CPED STAFF REPORT

Prepared for the Heritage Preservation Commission

HPC Agenda Item #4-6

Property Location: 602, 602 ½ and 606 North 1st Street
Project Name: 602 Residences
Prepared By: [Hilary Dvorak](#), Principal Planner, (612) 673-2639
Applicant: Curt Gunsbury
Project Contact: Charlene Rosie with Hess, Roise and Company
Ward: 3
Neighborhood: North Loop
Request: Demolish the buildings located at 602 and 606 North 1st Street and construct a new 8-story residential building

L2.0

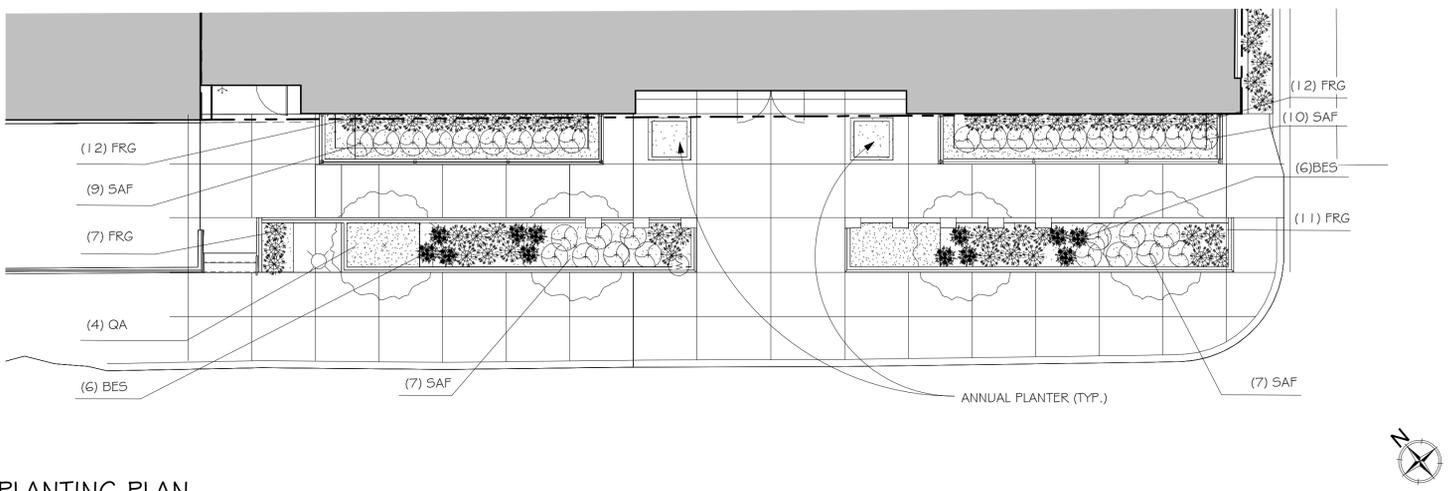
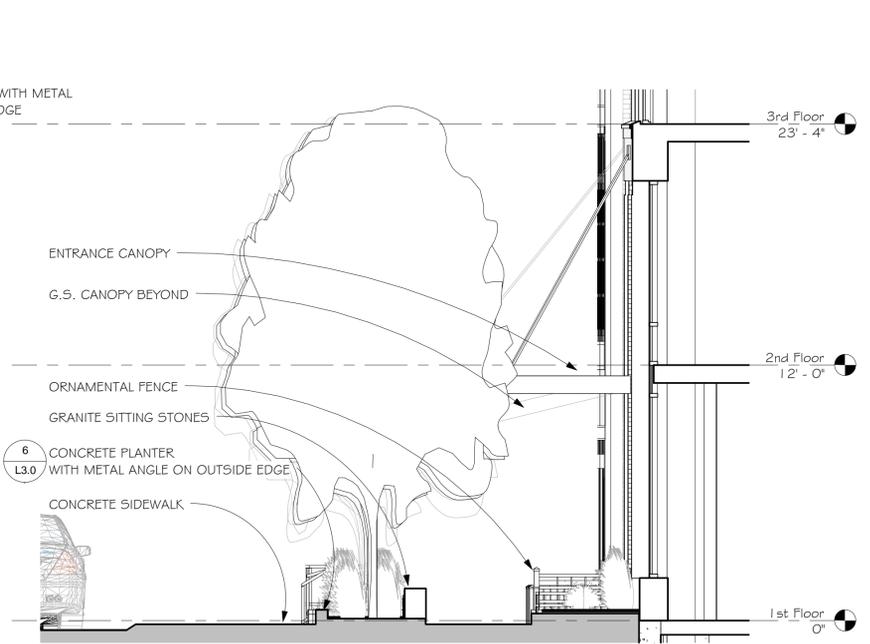
There is approximately a one-and-one-quarter foot grade change from the property line to the back of curb along North 1st Street. This is an existing condition that exists along North 1st Street beginning at this property and to the north along the street. To accommodate for the grade change the applicant is proposing to construct a raised planter mid-way between the curb line and the front of the building. The front of the planter will align with the railing at the outer edge of the raised platform that exists for the remainder of the block north of this site. The overall depth of the planter will be approximately five feet.
